PRODUCT:

- ST9 P/N 130-0132: P5 D-Ring: Rubber [OLD]
- ST9 P/N 130-0165: P5 D-Ring, Polyurethane [NEW]
- ST9 P/N 150-3030: P5 LBRT Red Fluid End
- ST9 P/N 150-3036: P5 LBRT Blue Fluid End

MODIFICATION:

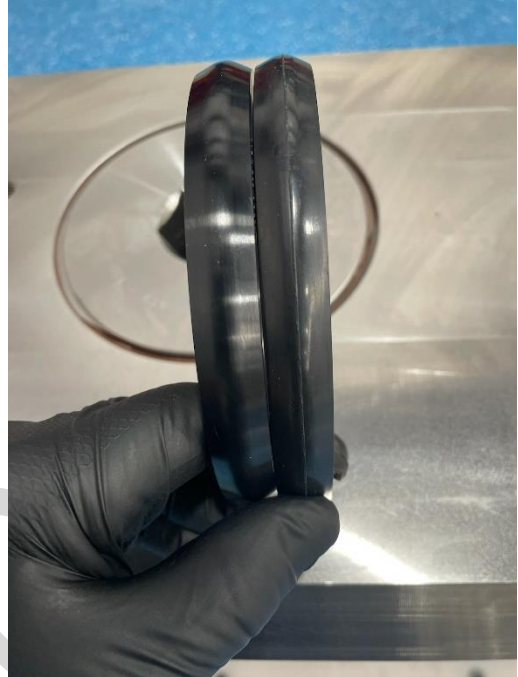
- 1) Future ST9 P5 fluid ends will now contain a D-Ring made of polyurethane instead of rubber. This change will apply to LBRT Red & Blue fluid ends and d-rings will be backwards compatible with existing inventory.

DETAILS: Due to concerns regarding life on rubber d-rings, the decision has been made to begin building P5 fluid ends with a urethane d-ring instead. These parts will be available for order immediately from ST9.

Note that in the pictures the urethane d-ring is slightly thicker and has more shine.
